HISTORIC PRESERVATION BOARD

AGENDA

PUBLIC HEARING
ST. LUKE'S CATHEDRAL, 143 STATE STREET

TO: Chair Pollard and Members of the Historic Preservation Board
FROM: Rob Wiener, Historic Preservation Compliance Coordinator
DATE: October 1, 2021
RE: October 6, 2021 PUBLIC HEARING – Final Review of Proposed
Landscaping and Site Improvements
HPBR-001735-2021

Roof Plan	
Project number	Portland, ME 04101
Date	Issue Date
Drawn by	Author
Checked by	Checker
A203	
Scale	1/4" = 1'-0"

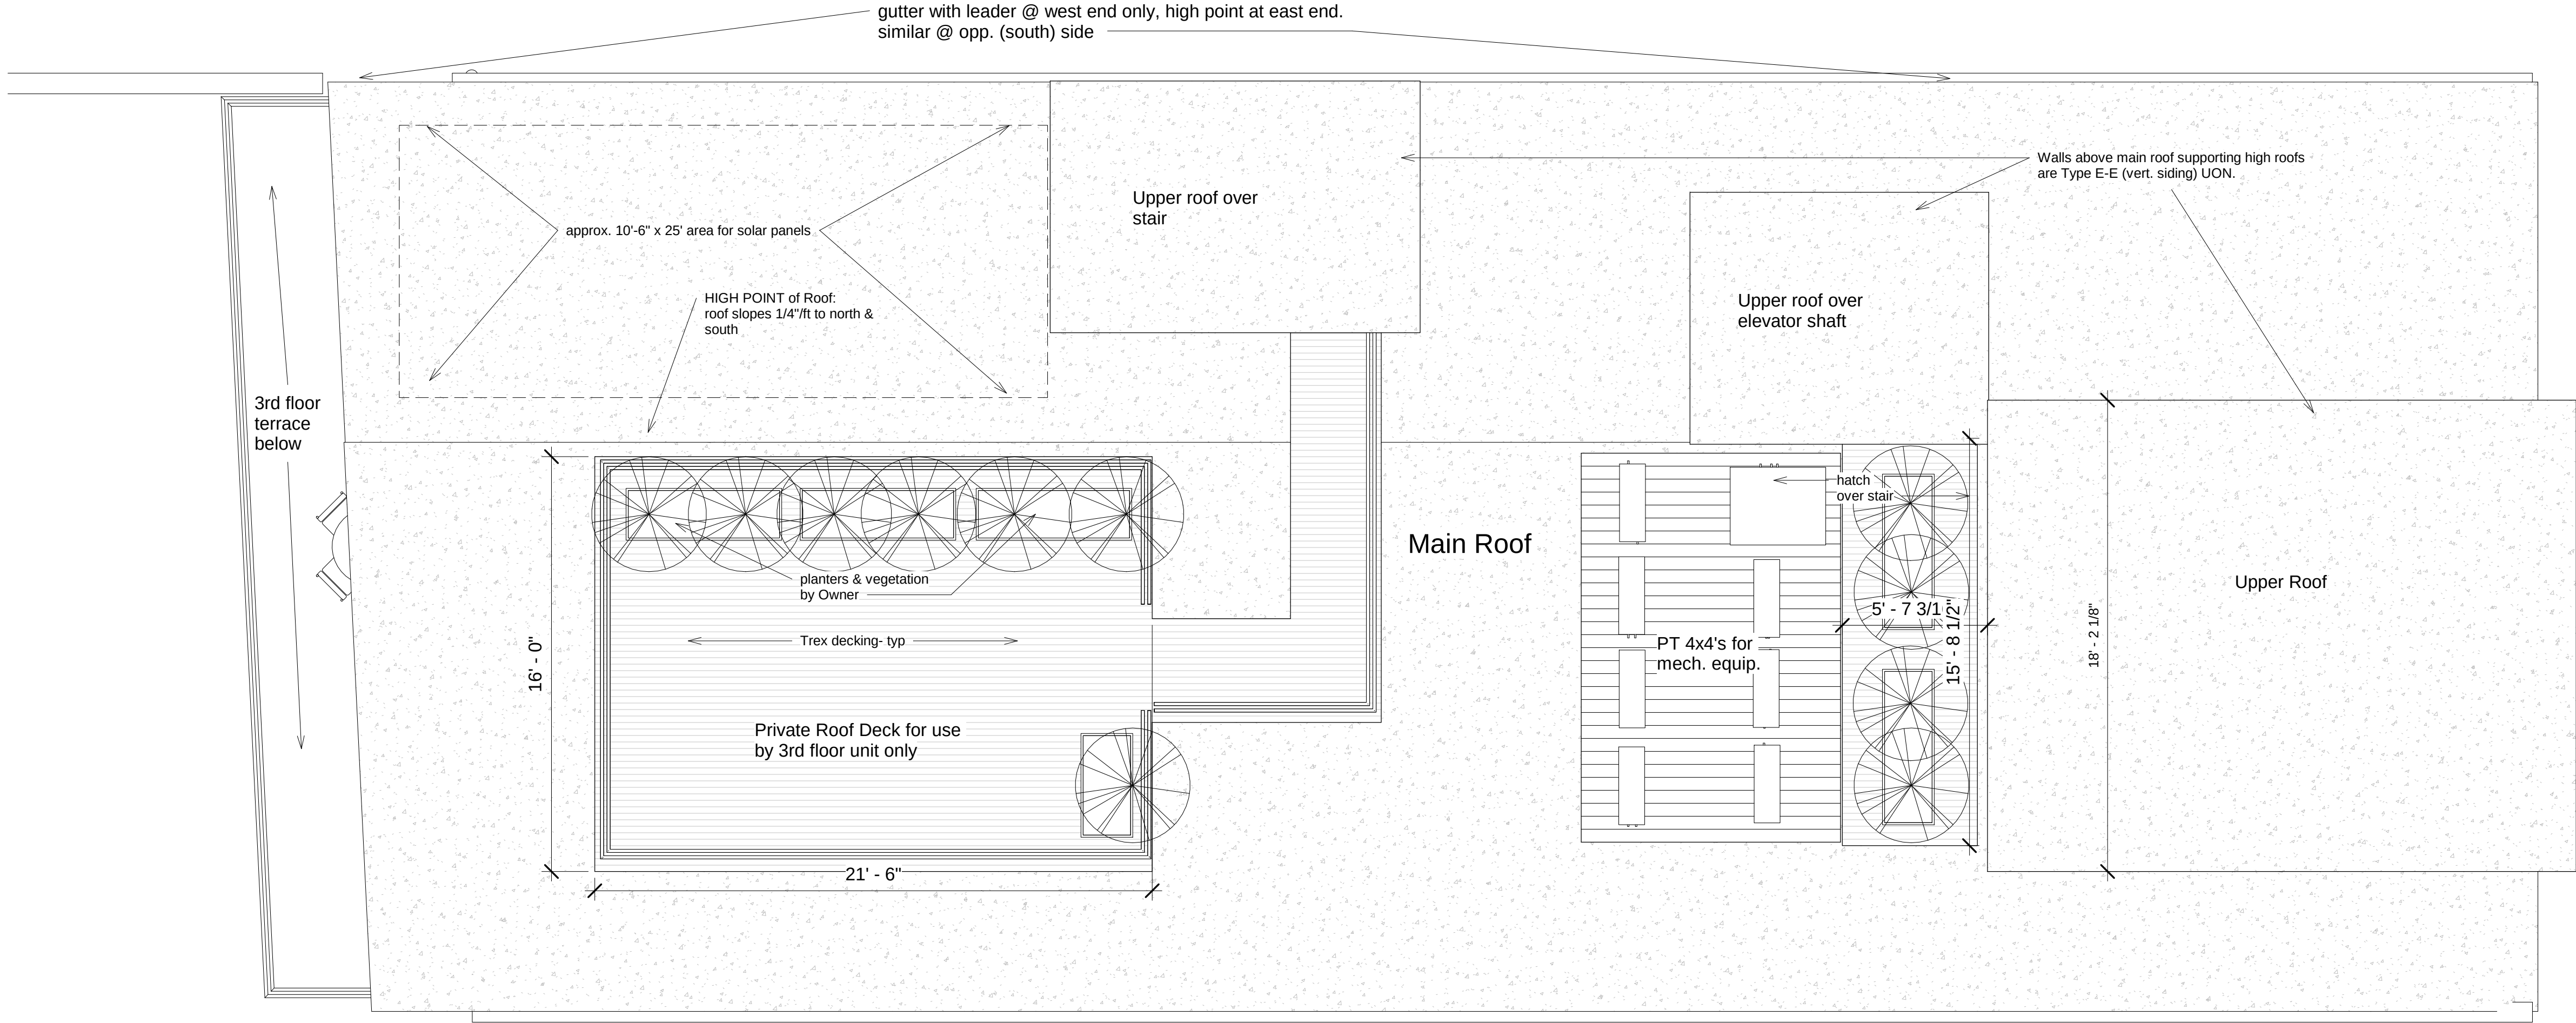
Note that the plans call for construction of a stairway bulkhead on top of the roof to provide access to a proposed rooftop deck. The height of the bulkhead would exceed the 35' maximum building height in the MHNCD and, according to the zoning administrator, would not be allowed as planned. In the MHNCD overlay zone, only chimneys and rooftop mechanicals (if shielded from view) are allowed to exceed the 35' height limitation.

Please revise building plan to conform to required height of 35'. While HVAC equipment shielded from view is allowed to be higher than this limit, the proposed stairway bulkhead is not.
